Service Bulletin #: SB16

Title: Sensor Interface Unit (SIU) CHT Recalibration

No Mod Applied

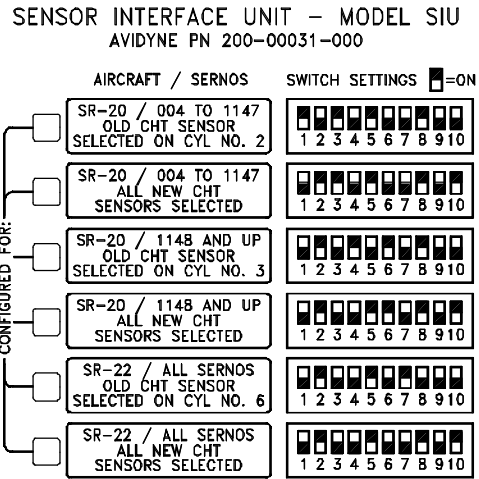
Note that there are no Mod Status blocks appearing below the "Avidyne PN" line.

- ?? "No Mod Applied": no mod blocks are present on the SIU label, or
- ?? "Mod 1 Not Accomplished": mod blocks are present on the SIU label but Mod 1 is not indicated.

Numbered Mods Applied

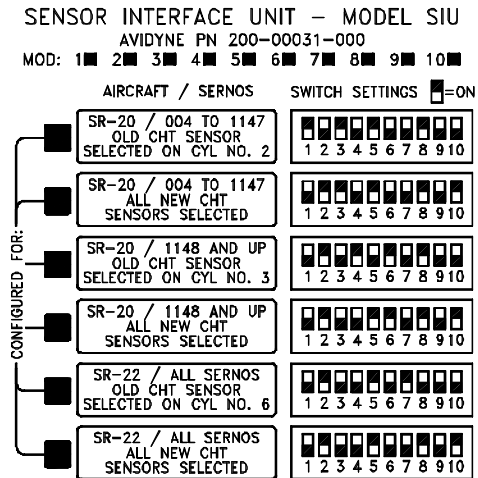
Note the "Mod. Blocks" appearing below the "Avidyne PN" line. All modifications are indicated by a mark in the corresponding "Mod. Block."
